NL-07-1200

Edwin I. Hatch Nuclear Plant
Request to Implement an Alternative Source Term
Response to Request for Additional Information Regarding the
Unit 1 Main Steam Isolation Valve Alternate Leakage Treatment Path Evaluation

Response to Request for Additional Information Regarding the
Unit 1 Main Steam Isolation Valve Alternate Leakage Treatment Path Evaluation

FIGURE 1:
SCHEMATIC OF LEAKAGE CONTROL PATH

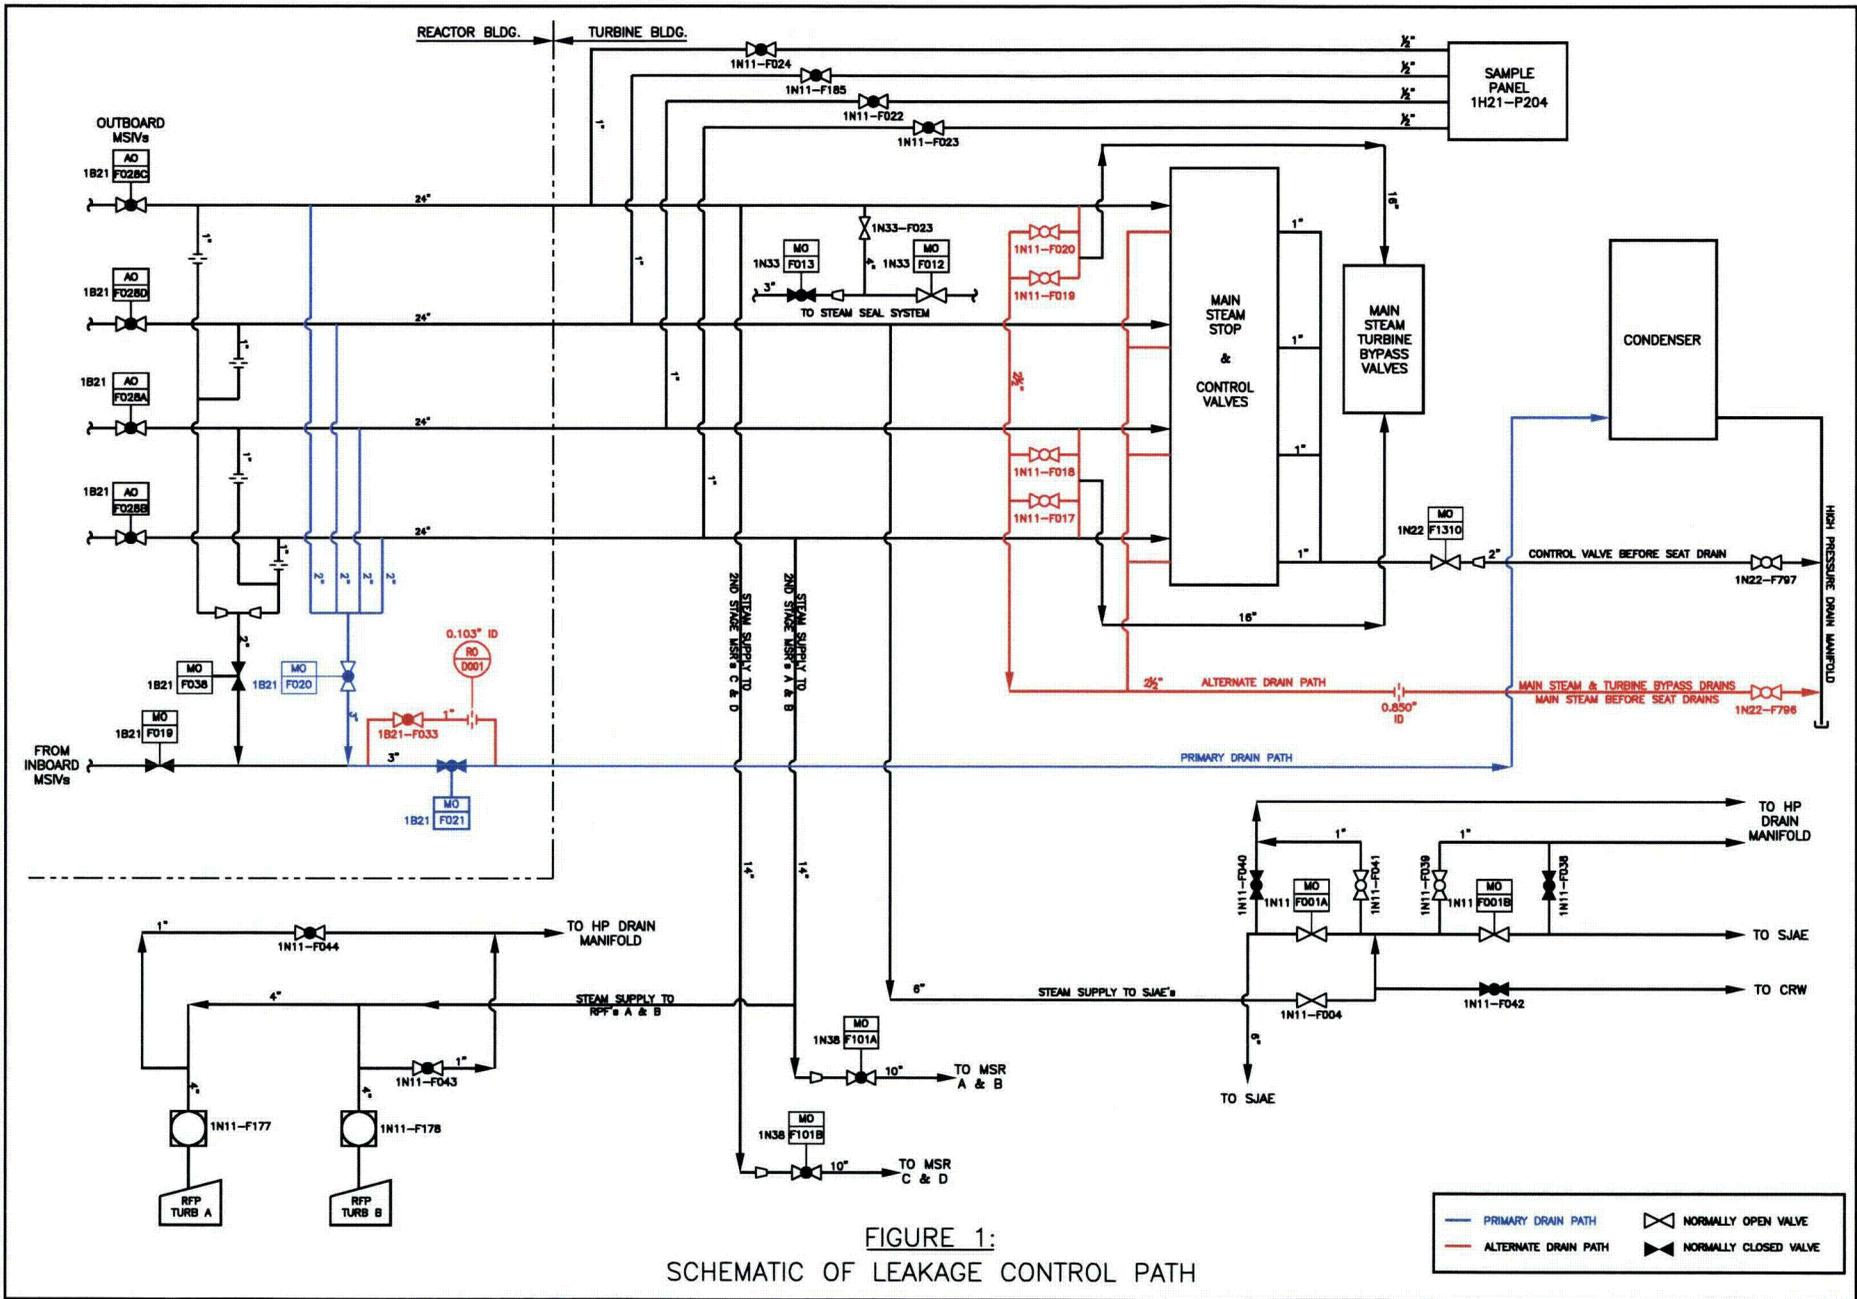
In the attachment, “Edwin I. Hatch Nuclear Plant Unit 1 Main Steam Isolation Valve Alternate Leakage Treatment (ALT) Path Description and Seismic Evaluation,” on page 1, of the above report information is provided to ensure that the ALT pathway boundary is isolated and that the release is via the condenser. When the list of valves that close automatically and those that require operator action to be closed is compared to Figure 1, “Schematic of the Alternate Leakage Treatment (ALT) Path,” a path still exists to “CRW” through valves 1N11-F004 and 1N11-F042.

- A. Please define the Acronym “CRW” as it is not defined in the submittal.
- B. Please provide justification for why provisions to isolate the potential release path to “CRW” are not provided.
- C. Please confirm that “Sample Panel 1H21-P204” provides an adequate boundary which can be relied upon in the event of a loss-of-coolant accident, and does not require additional isolation.

- A. CRW is the acronym for clean radwaste.
- B. The attachment referenced in this RAI was provided as enclosure 8 to the SNC alternative source term (AST) submittal dated August 29, 2006. The referenced page and figure provide a description of the Unit 1 MSIV ALT path. Due to an error on the referenced Figure 1, it appears that there exists a potential release path to CRW. Specifically, valve 1N11-F042, a 1-inch manual valve in a drain line off the steam line, is normally closed; it was inadvertently shown as open on Figure 1. A revised Figure 1 correctly showing 1N11-F042 as normally closed is provided to replace the Figure 1 previously provided in both enclosures 1 and 8 of the AST submittal. Valve 1N11-F004 is a 6-inch manual gate valve in the steam line to the steam jet air ejectors (SJAE) and is correctly shown in Figure 1 as normally open. Therefore, the potential release path to CRW is properly isolated by the normally closed valve 1N11-F042.

- C. As described in the following, sample panel 1H21-P204 provides an adequate boundary which can be relied upon in the event of a loss-of-coolant accident (LOCA) and does not require additional isolation.

Sample panel 1H21-P204, as shown in the previously referenced Figure 1, is located in the water analysis room in the control building. It is the sample hood at which grab samples are taken. The sample panel was labeled as 1H21-P204 on Figure 1 for diagrammatical purposes. Sample lines from the main steam lines are routed to the water analysis room where the lines split and initially enter sample panels 1H21-P205 and 1H21-P206. There is a normally closed sample inlet valve for each line within 1H21-P205 and 1H21-P206. These closed manual valves are the ALT path boundary valves for these lines. Operator action is required to open these valves to establish sample flow. Samples from 1H21-P205 are then routed to sample hood 1H21-P204 for grab samples and samples from 1H21-P206 go to analyzers on panel 1H21-P208.
